Campaign No. 2020050029 March 2021

SUBJECT: **Model E-Class diesel vehicles (212 platform)**
Model Year 2014-2015 with OM651
Modification to the emission control system

Mercedes-Benz USA, LLC ("MBUSA") is performing an emission campaign on certain E-Class diesel vehicles in order to modify to the vehicles' emission control system. EPA and CARB have approved this emission modification for the MY14 - 15 E-Class (212) diesel vehicles. An authorized Mercedes-Benz dealer will replace certain emission control system components and update certain software in the affected vehicles at no cost to the owner of the vehicle.

Figure 8

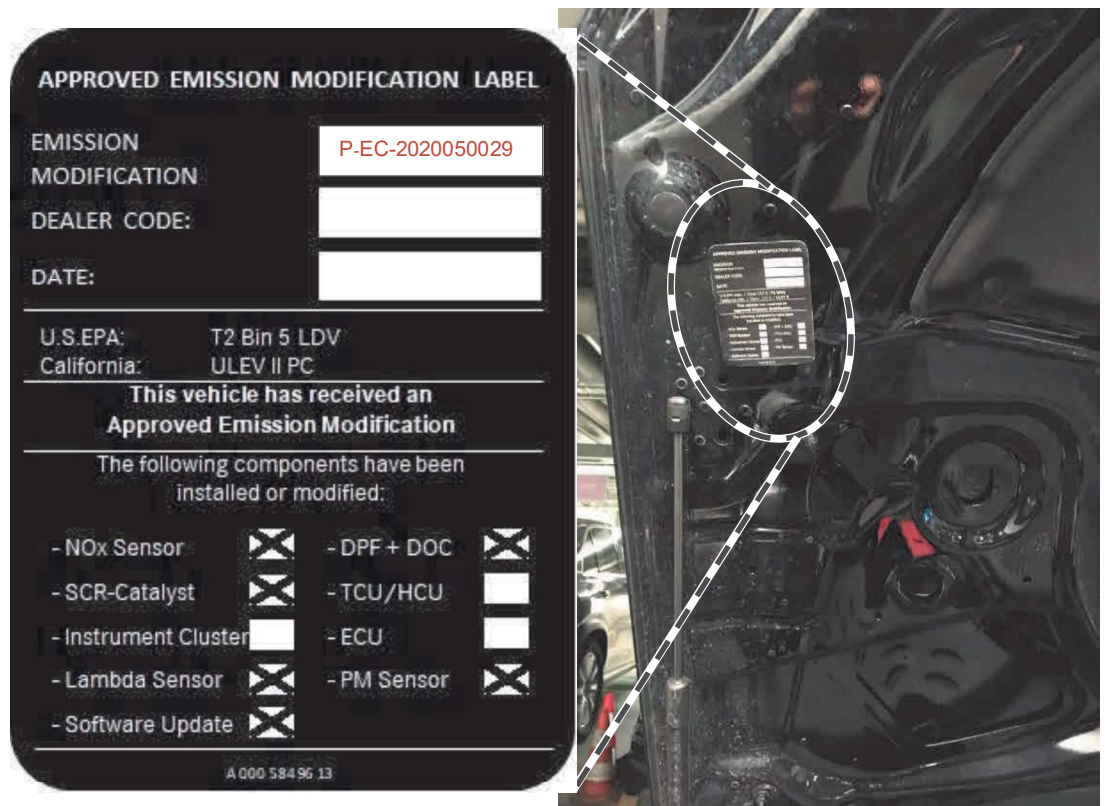
14. Clean the bonding surface of the hood and attach the AEM-label (**Figure 8**).

i The fields on the adhesive label must be filled out correctly. Please use black permanent marker.

i The adhesive label can be applied to the hood **while** updating the software for the engine control unit.

i **Failure to comply may result in dealer debit and/or possible fines.**
